**STAFF RECOMMENDATION**  
**1003 Russell Street**  
**March 15, 2017**

**Application:** New construction – addition; Setback determination  
**District:** Lockeland Springs-East End Neighborhood Conservation Zoning Overlay  
**Council District:** 06  
**Map and Parcel Number:** 08309020800  
**Applicant:** John Root, RootArch  
**Project Lead:** Paul Hoffman; paul.hoffman@nashville.gov

**Description of Project:** Addition and alterations to a non-contributing building. A setback determination is requested for the front and left sides, from fifteen feet (15') to ten feet (10') and six feet (6') respectively.

**SITE PLAN**

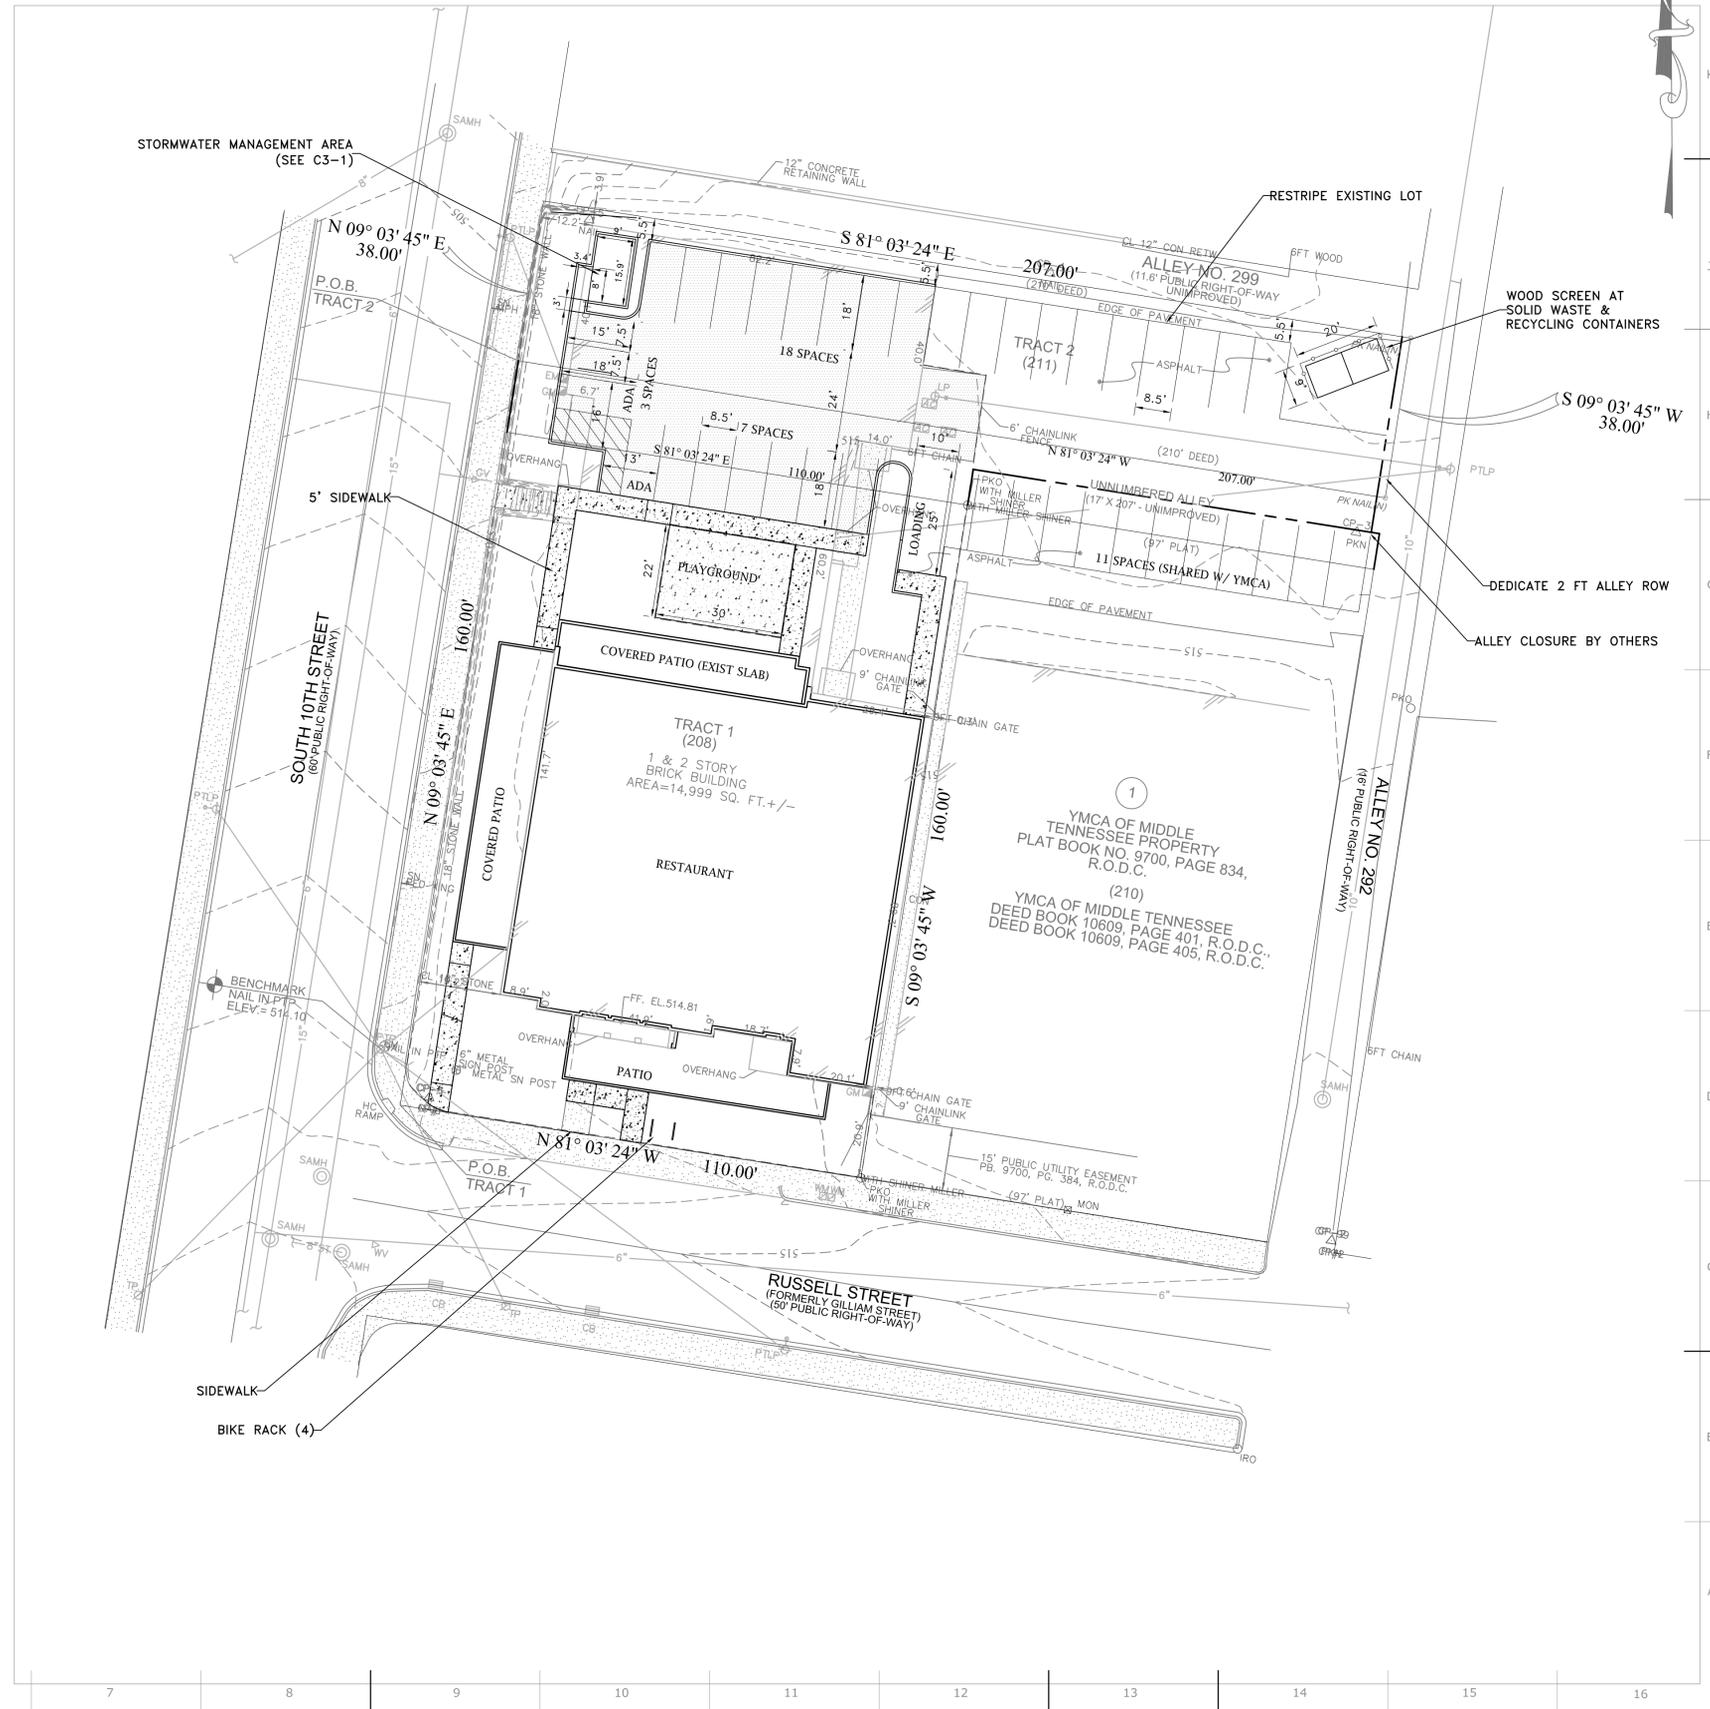
Setbacks: The base zoning for CS requires a street setback of fifteen feet (15') from both Russell Street and South 10<sup>th</sup> Street. The new covered patios are proposed at ten feet (10') from Russell Street and six feet (6') from South 10<sup>th</sup> Street. Staff finds the proposed setbacks to be appropriate for several reasons. There is little historic context for setbacks in the immediate vicinity. The YMCA building next door along Russell Street is non-contributing, as is the structure behind 1003 Russell Street which fronts Woodland Street. Across the street from 1003 Woodland Street is new multi-family infill that MHZC approved in 2015. Given the lack of historic context, reducing the setbacks at 1003 Russell to ten feet (10') and six feet (6') will not affect the historic character of the neighborhood. Historically, commercial and institutional structures like this one sat closer to property lines than single-family and duplex houses. Also, the new construction is covered patios, which have more visual permeability than if it were enclosed space. For these reasons, staff recommends approval of the reduced setbacks.

A new chain link fence is proposed around the parking area at the rear. Section II.B.9 states that appurtenances “shall be visually compatible with the environment of existing buildings and sites to which they relate.” Staff’s review is that chain link is not

appropriate, and recommends an alternative material to be more compatible. Staff requests final approval of windows, doors, masonry, and patio construction materials. With revised fencing, and final review of materials, the project will meet section II.B.4.

Staff recommends approval of the setback determination, and finds that the project meets section II.B.3 for setbacks.

1. Staff approve the final details, dimensions and materials of porch materials, masonry, windows and doors prior to purchase and installation;
2. Fencing is changed from chain link to a more compatible material, to be approved by staff.
